The SW Ecodistrict Plan

ADDENDUM

SEPTEMBER 2014

NCPC RESPONSE TO PUBLIC COMMENTS

INDEPENDENCE AVENUE EXISTING AND PROPOSED SETBACKS

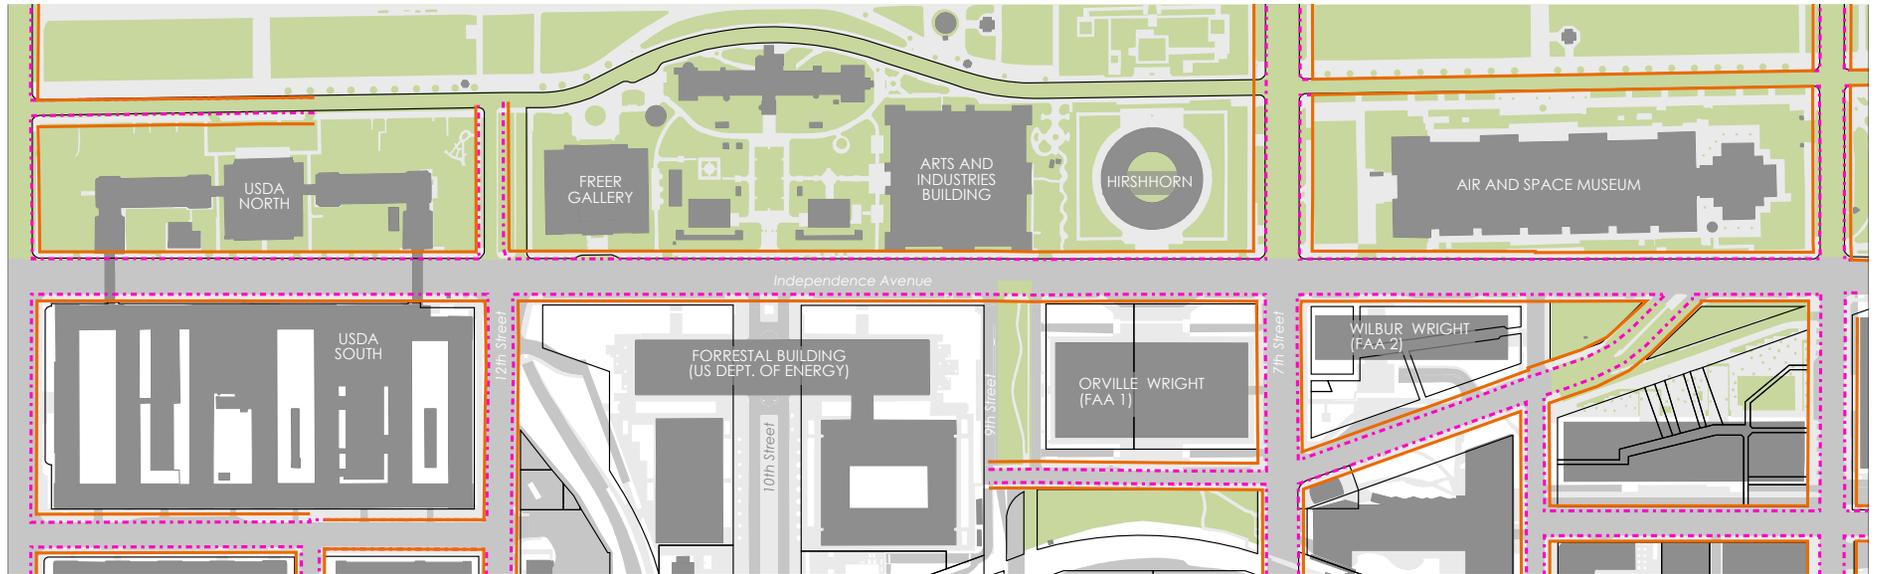
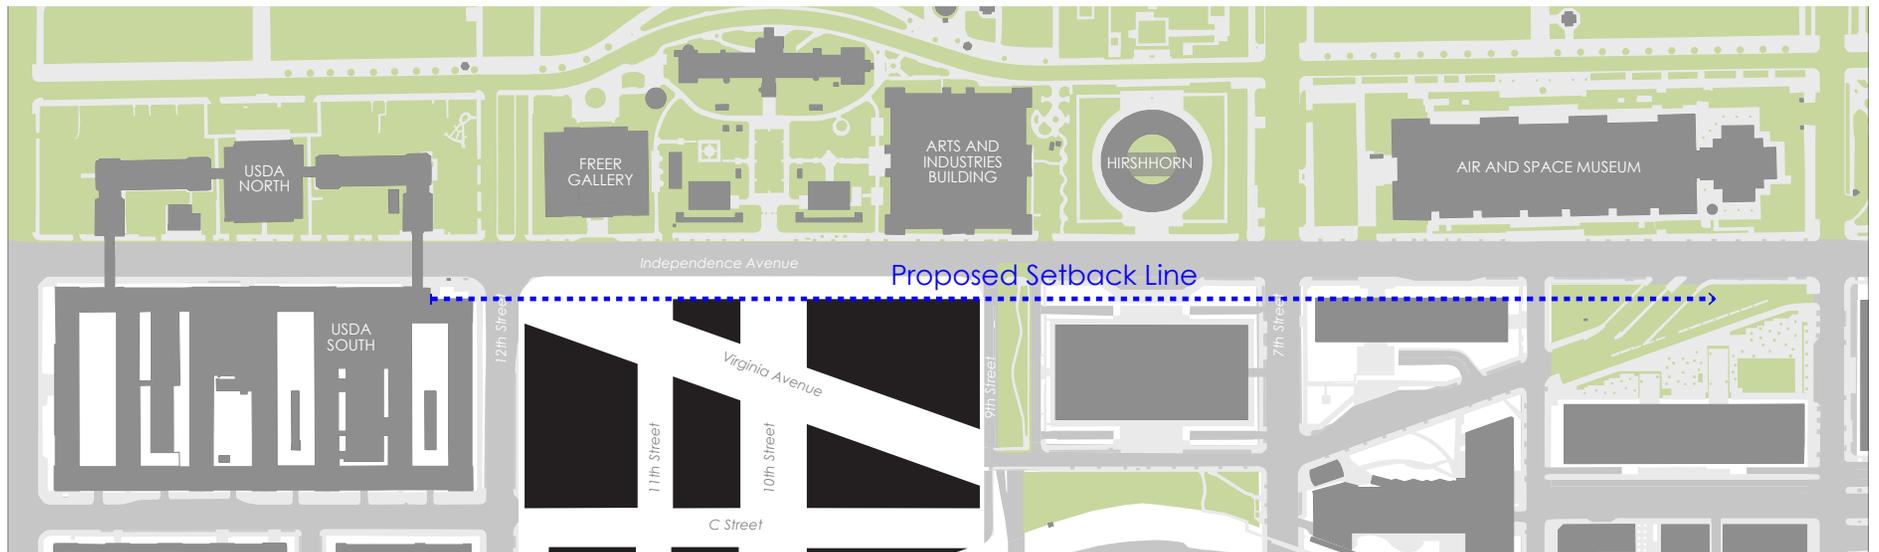
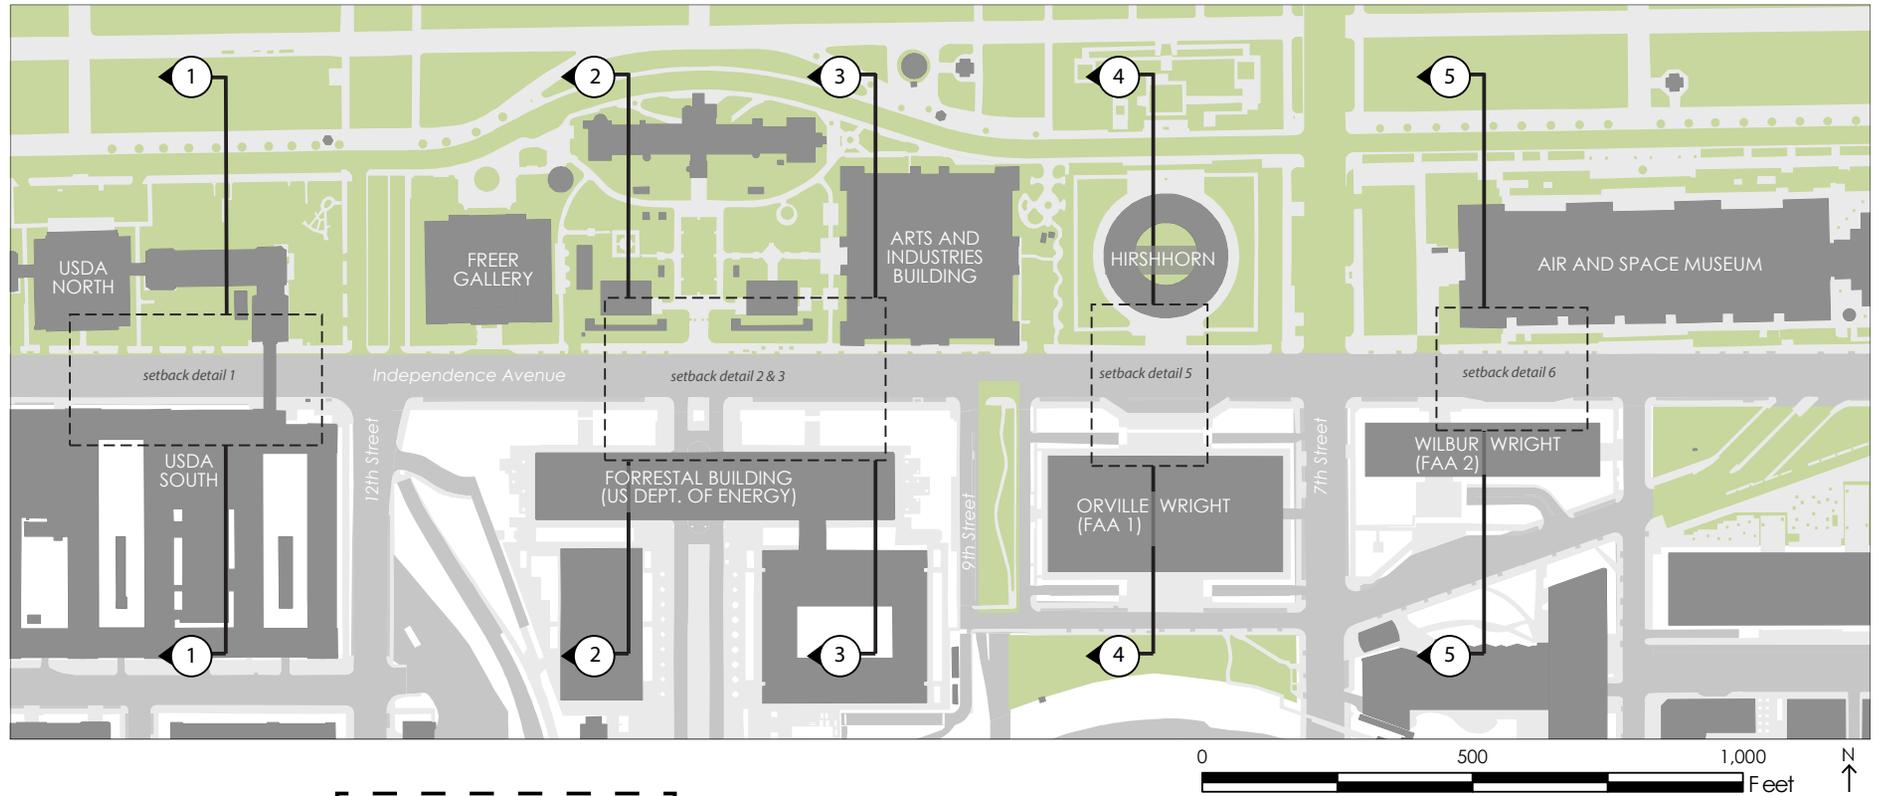
Comments by Section <i>Street Character cont.</i>		
Public Comment	Response	
20	<p>Independence Avenue: Page 13 — Please explain the red line shown in the diagram now in lower right corner; unexplained, it looks like some kind of building restriction line (unwanted mandate, not what an Addendum should impose if that’s what it is).</p>	<p>The red line in the diagram on pg. 14 illustrates the proposed build-to-line on Independence Avenue that informed the SW Ecodistrict Plan. It is 34’ from the southern right-of-way line (it varies from each property line). The rationale for this setback is that potential new development along Independence Avenue would create a strong building line that aligns with the inset of the USDA South building at the corner of 12th and Independence. It also allows for more open space than the existing sidewalk in front of the USDA South building. Several of the existing buildings are set back much further which mitigates the impact of the building height on views from the Mall (for example the Orville Wright building is 130’ in height but is set back 87’ from the property line).</p> <p>The SW Ecodistrict Plan and Addendum are only guidance. Staff will consider public/stakeholder comments on the Addendum when commenting on the District’s zoning proposal for the area or conducting additional studies.</p>
